ADDENDUM NO. 2
Columbia Co Bid No. 2023-12
Ellisville to Fort White Water Main Extension

The following changes to Bid Documents

PROJECT NAME: Ellisville Water Main Extension
COLUMBIA COUNTY BID NO: 2023-12

MS01 ALTITUDE VALVE ASSEMBLY
SCALE: N.T.S

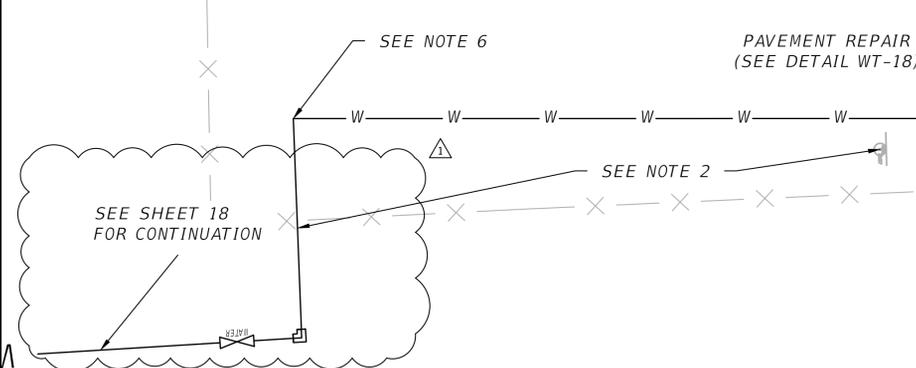
- Q7. *On Detail MS02, it calls out for an 8" x 84" spool piece, but on the other side of the detail it's an 8" x 24" spool. Is this correct?*
- A7. **The dimensions are correct as shown in Detail MS02 (note that the detail is not drawn to scale).**

SHEET NO.
19

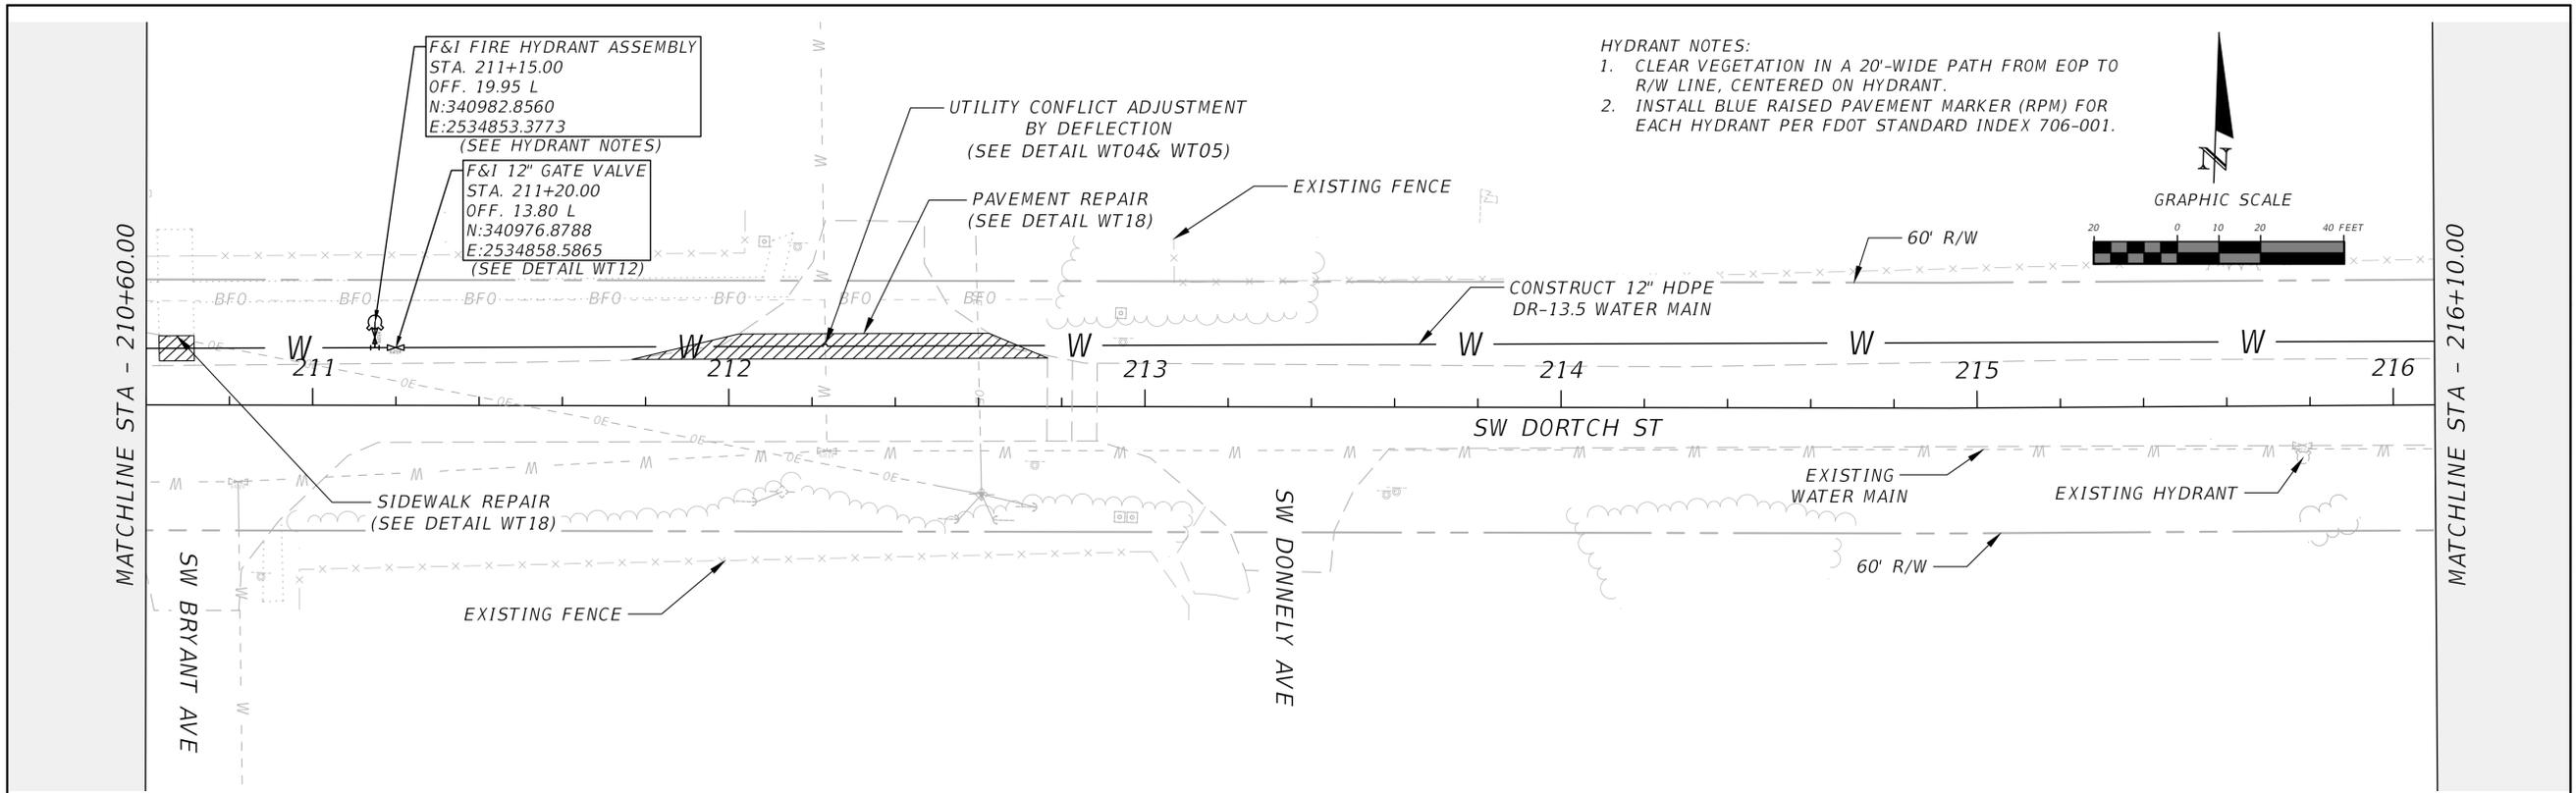
1. In Project Drawings, replace Sheets 18, 19, 20 and 65 with the attached revised Sheets 18, 19, 20 and 65. These sheet replacements resulted from the above-mentioned water main realignment.

REVISIONS	
DATE	DESCRIPTION
1/18/24	REALIGNMENT PER ADDENDUM NO. 2 (REPLACES PREVIOUS SHEET 19)
